URGENT IMPORTANT FIELD SAFETY NOTIFICATION

Subject: Incorrect source step size may occur in Oncentra Brachy plans for Ring or Venezia applicator models with microSelectron.

Product: Oncentra® Brachy.

Scope: Oncentra Brachy versions 4.5, 4.5.1, 4.5.2.

Figure 2. Example of the 3D reconstruction area with the differences in the step size.

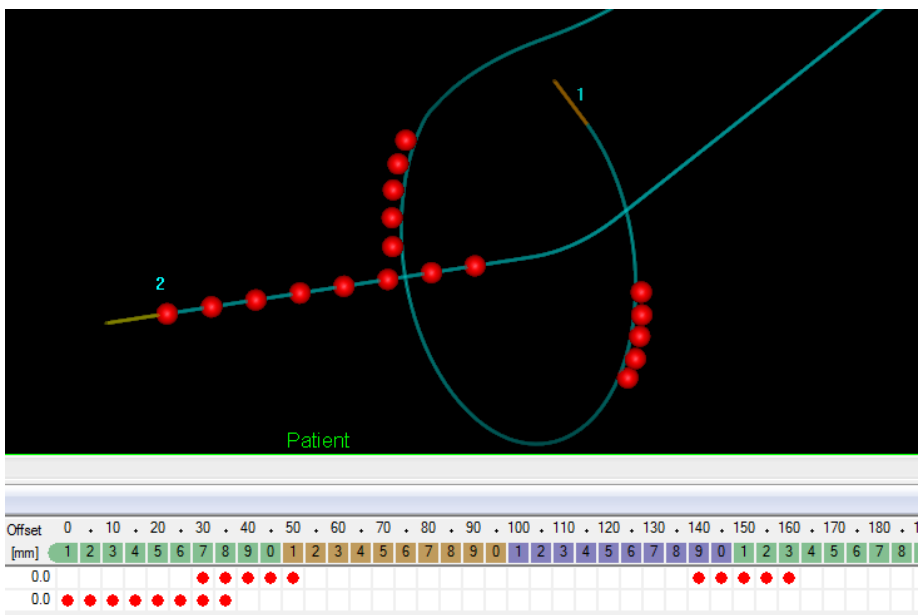
The 3D view of the applicator will show a step size of 2.5 mm for the ring and 5.0 mm for the tandem, see Figure 2. When activating dwell positions in the Case Explorer, it seems a 5.0 mm step size is used, while the 3D view shows a 2.5 mm step size for the ring.

The dose calculated for the plan will correspond to a 2.5 mm step size for the ring and a 5.0 mm step size for the tandem. The Oncentra Brachy Treatment Printout will show a 5.0 mm step size for both ring and tandem. When this plan is exported, a step size of 5.0 mm will be sent to the microSelectron afterloader. The afterloader Pre Treatment Report will show a 5.0 mm step size as will be delivered by the afterloader.

Until an upgraded version of Oncentra Brachy is available, it is strongly recommended to only use a default source step size of 2.5 mm for microSelectron afterloaders in RDStore.

If a larger default source step size is required in RDStore, a workaround is to reselect the same afterloader in the Prescription dialog in the Oncentra Brachy planning module. The source step size is then forced to the correct value of 2.5 mm.
